REQUEST FOR INFORMATION NOT ADDRESSED IN THIS CCO REMAIN IN FORCE					
2	08/08/11	W2 DUCTBANKS REINFORCEMENT	MG TW	RG	205
1	01/14/11	BASE INTEGRATION	RSB	WB	150
MARK	DATE	DESCRIPTIONS	BY	CH'D	CCO#
REVISIONS

CONTRACT CHANGE ORDER NO._____
SHEET_____ OF _____

UNDERGROUND
DUCT BANKS AND MANHOLES
SCALE 1:200

E-11

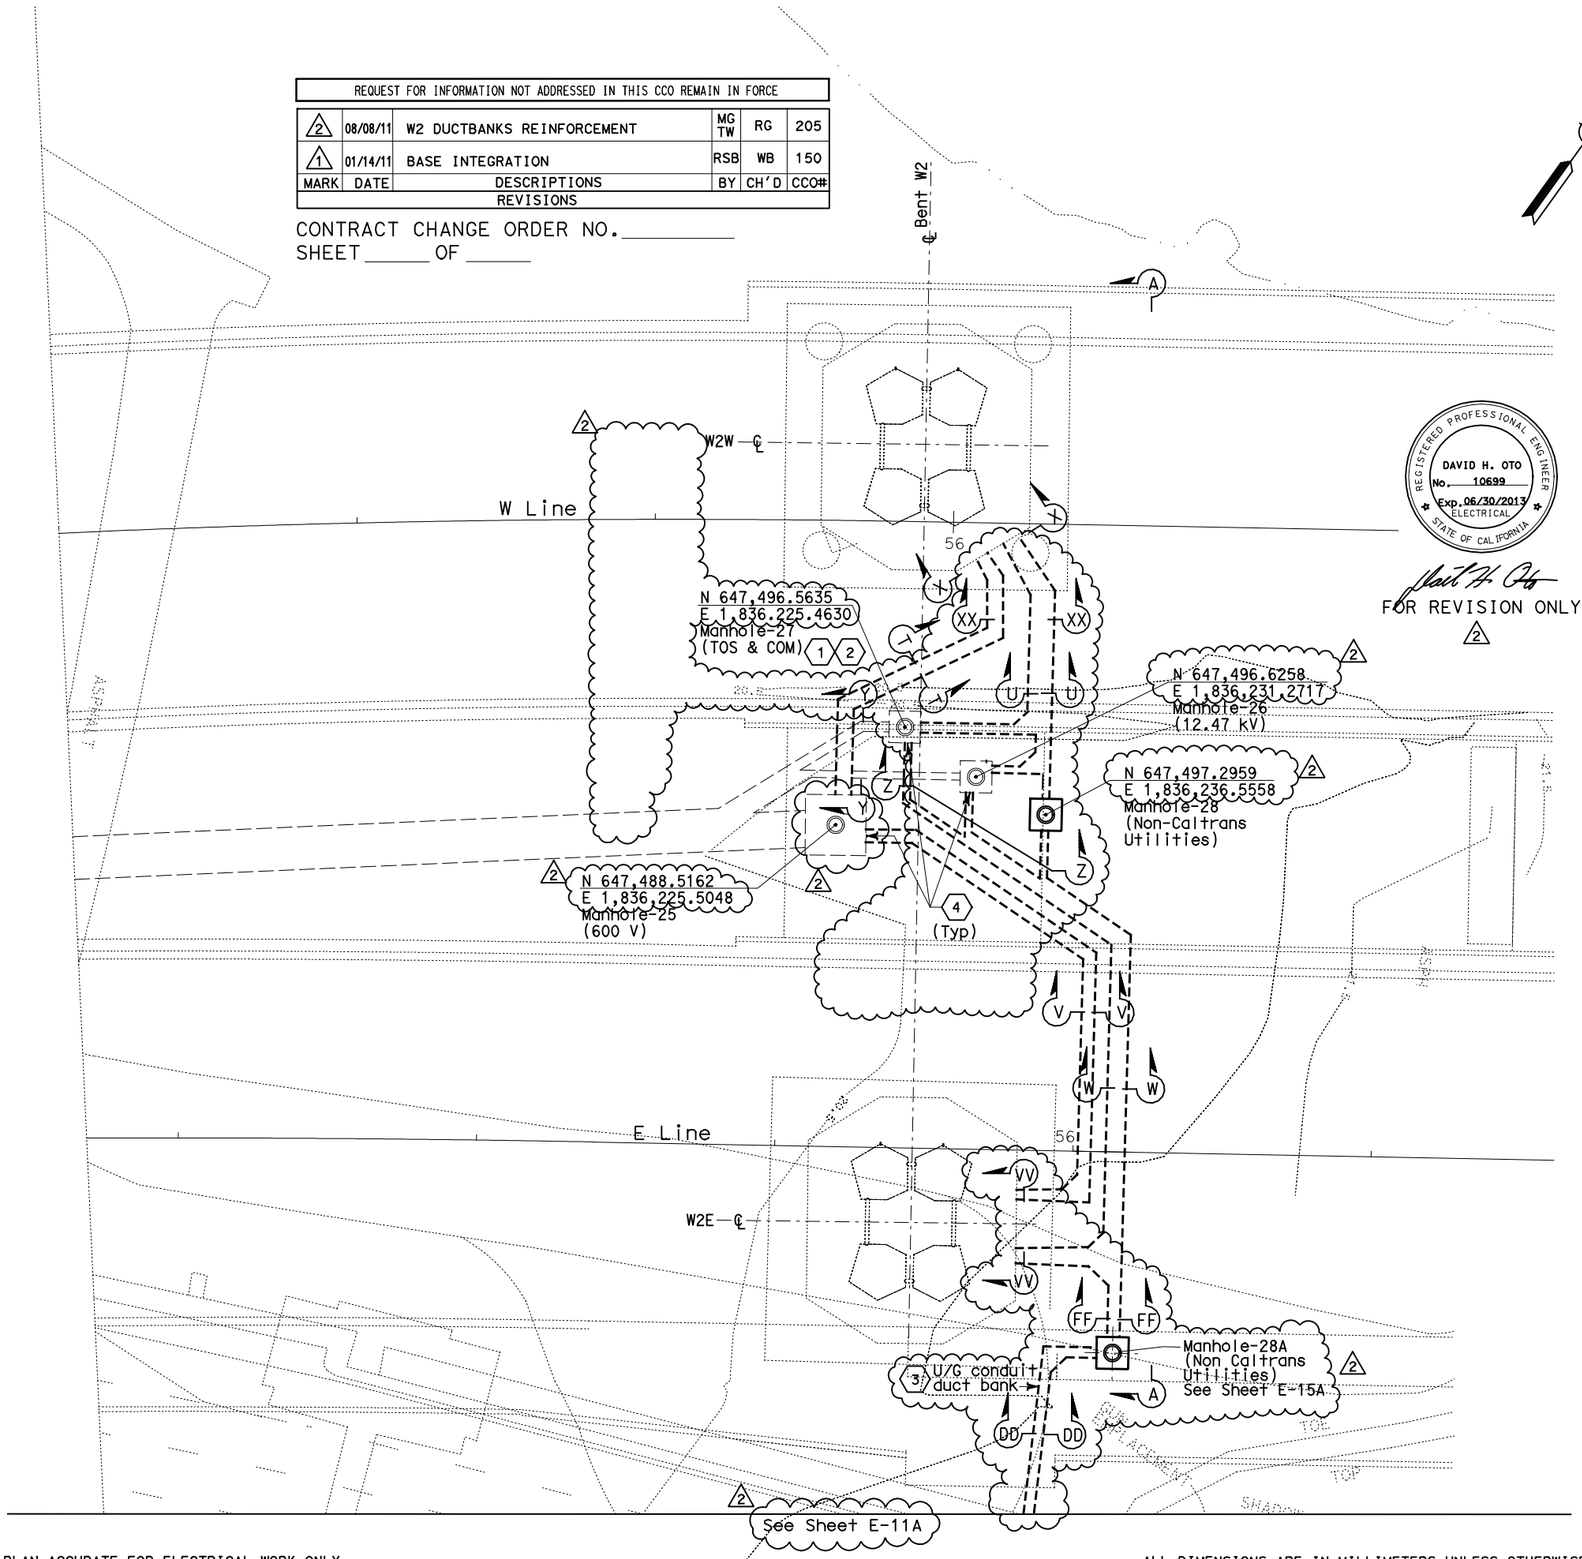
1. References:
   - For manhole plans and sections, see sheets E-14 through E-16.
   - For typical manhole and duct bank details, see sheet E-17.
   - For duct bank sections, see sheets 19, 19A, 19B and E-23. (2)
   - For pier W2W plans and sections, see sheet E-20.
   - For pier W2E plans and sections, see sheet E-21.
   - For circuit and conduit/cable tray schedules, see sheets starting at E-401.
   - (2) Underground conduit duct bank shall be provided with additional reinforcement. For details, see sheet U-4, E-19C and E-19D.
2. For other related work, not shown on this sheet, see Electrical Special Provisions.
3. For location of manholes, see utility sheets.
4. For duct bank anchors on slopes, see utility sheets.
5. (2) Refer to Utility Duct Bank Profile and Details, see sheet E-23.

(2) Furnish and install BASE fiber optic cable in innerduct. See sheet E-1100.

(2) (3) The conduits exiting from the west wall of manhole MH-28A down to (E) AT&T Hut manhole shall be rigid pvc,schedule 40. Conduit 90 degree bends, risers or exposed to grade shall be rigid steel conduit.
